MARIN WOODS PLANNED RESIDENTIAL DEVELOPMENT GEORGE F. MARIN TRUST PRELIMINARY PLAT UTILITY / SITE MAP & UTILITY PLAN

Staff have reviewed the site plan application and associated documents for the proposed Marin Woods PRD in accordance with the Oak Harbor Municipal Code (OHMC). Staff provided you with review comments at the meeting on December 17, 2015. A copy of the review comments as discussed during the meeting has been enclosed with this letter. Please consider the review comments prior to resubmittal of your preliminary plat and related documents.

The following comments apply to the application as reviewed to this date and are based on the submittal received on November 6, 2015. Refined comments may be provided upon submission of revised plans or as changes are made to the application.

SW SWANTOWN AVE CHANNELIZATION
SCALE: HORIZ 1" = 20'

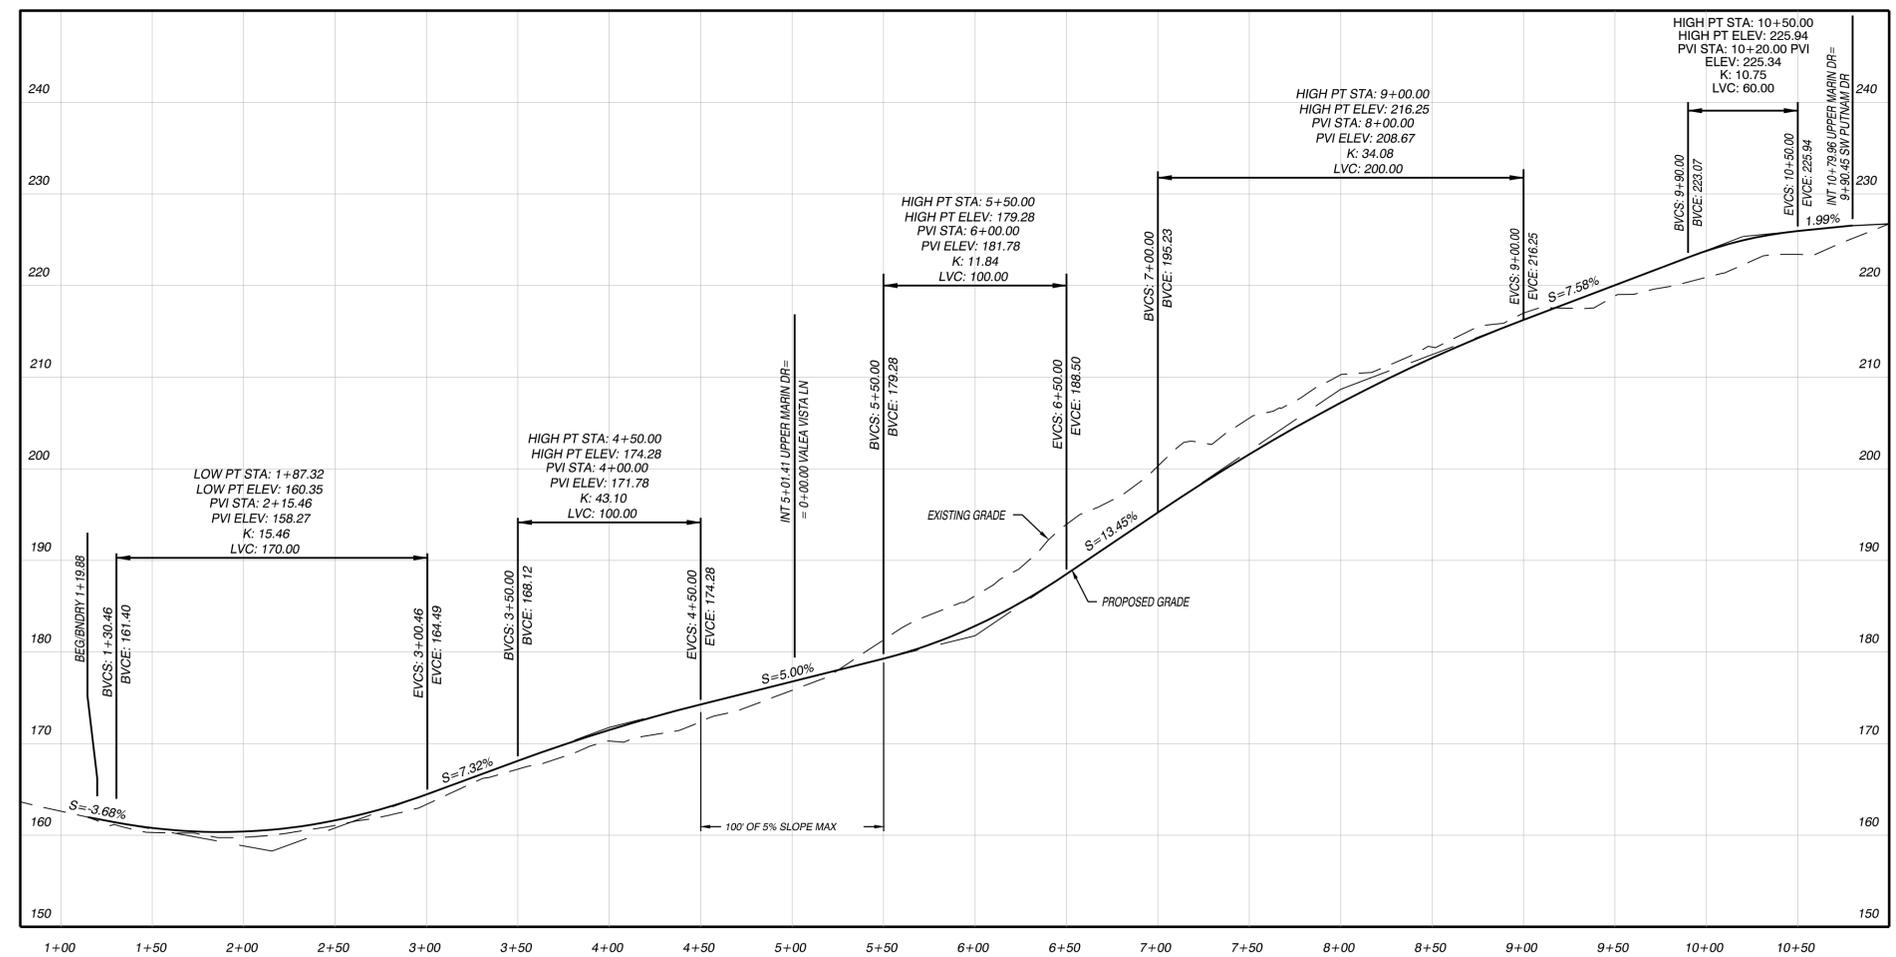
11. The intersection does not align on each side of S.W. Swantown Avenue. Provide an intersection design that aligns the channelization. In addition, the driveway for parcel R13204-427-4060 (Henman) needs to have proper spacing from the proposed intersection. OHMC 21.60.100

12. Reviewer needs designer to provide explanation of the proposed Swantown cross section and intersection design.
13. Sheet P7 indicates a retaining wall under the sidewalk along the parcel R13204-427-4060 (Henman). Please be aware that any retaining wall that will become a public improvement must have a provision for maintenance access. In addition, no street frontage utility easement is provided along the retaining wall.

MARIN WOODS
 PLANNED RESIDENTIAL DEVELOPMENT
 GEORGE F. MARIN TRUST
PRELIMINARY PLAT MAP
 EXISTING CONDITIONS

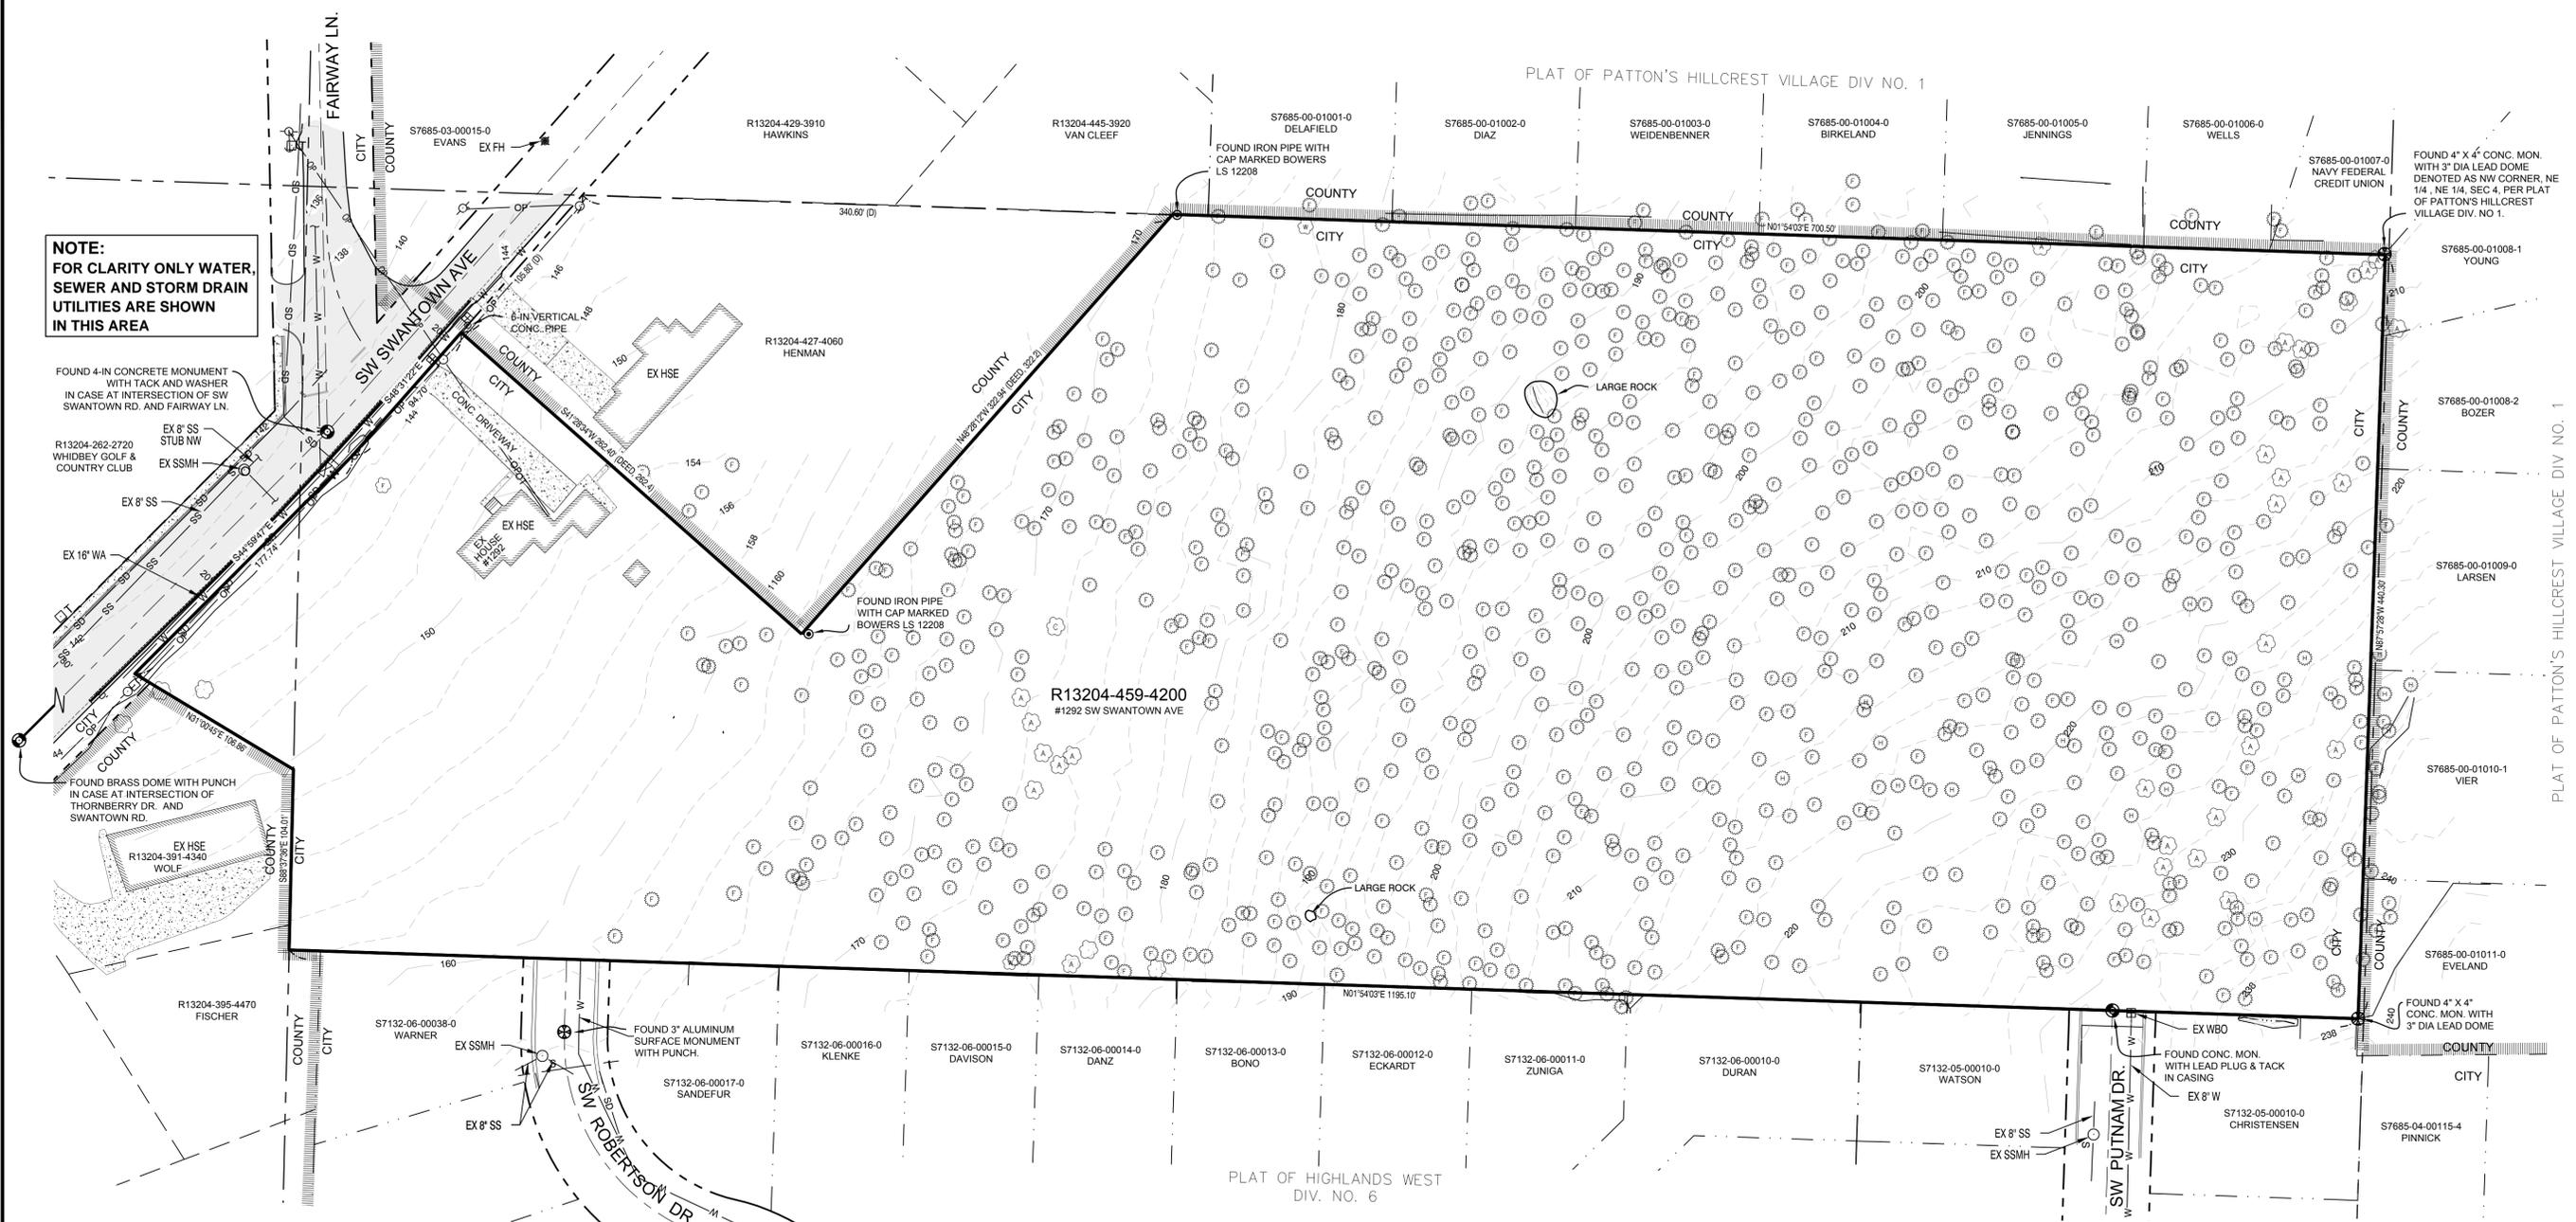
8. PRD Setbacks. Plans show differing home plans between pages P2 and PL-1. Page P2 includes text reference to 10 foot front and rear setback and 5 foot side setbacks. Please note that garages will need to be set back from front of home in order to meet the PRD requirement listed below, and at least 20 feet of driveway must be provided to allow for off-street, on-site parking. Applicant should ensure that homes meet criteria set forth in 19.31.170 with regard to design and total lot coverage limitations. If smaller lots from what is required in the underlying zone district are being proposed, the buildings on these lots must meet requirements (a) to (c) below or requirement (d) or (e).

13. Sheet P2 does not show plan view of proposed Swanton Avenue street improvements.
14. Indicate proposed lanes, etc. (channelization) for the Swantown Avenue, similar to detail 4/P6.

UPPER MARIN DRIVE PROFILE

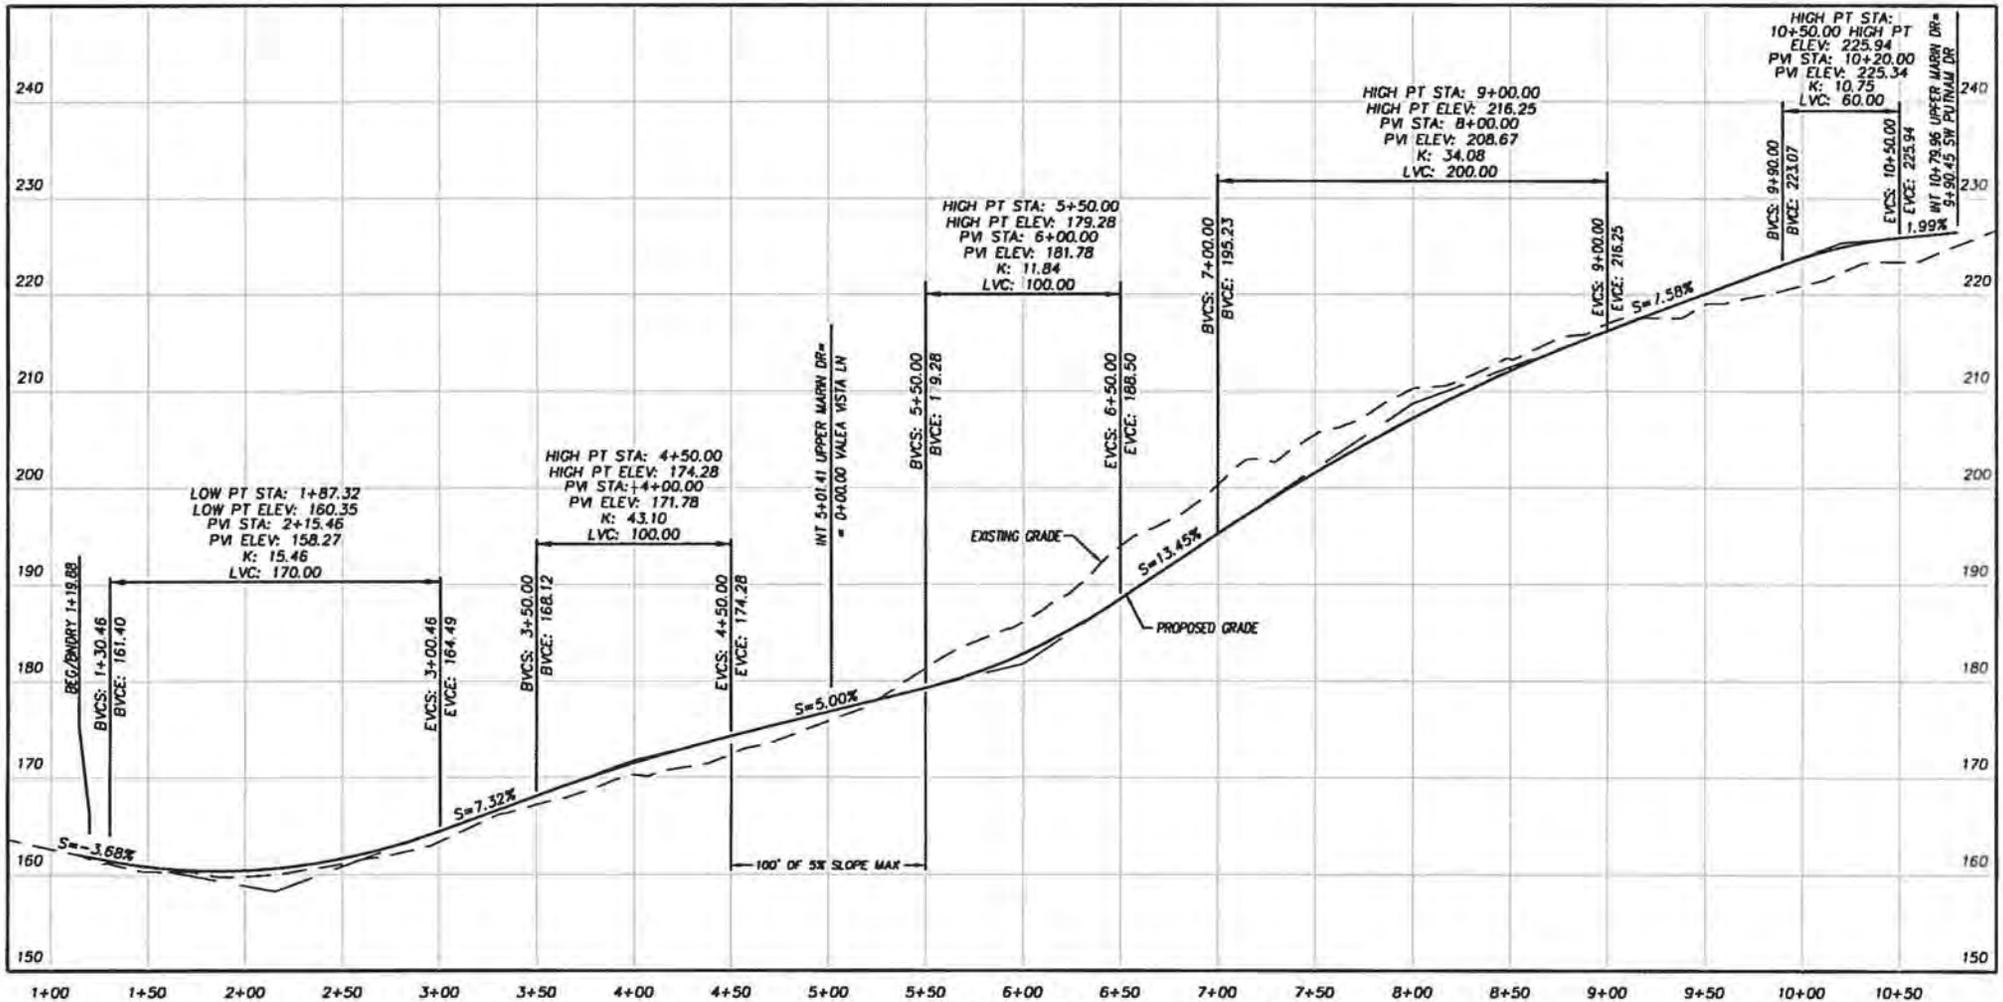
In particular, we are seeking a waiver to allow approximately 350 feet of road grade on proposed Upper Marin Drive at approximately 14%, measured PVI to PVI. Please See Sheet C2, Upper Marin Drive Profile, sta 6+00 to sta 8+00.
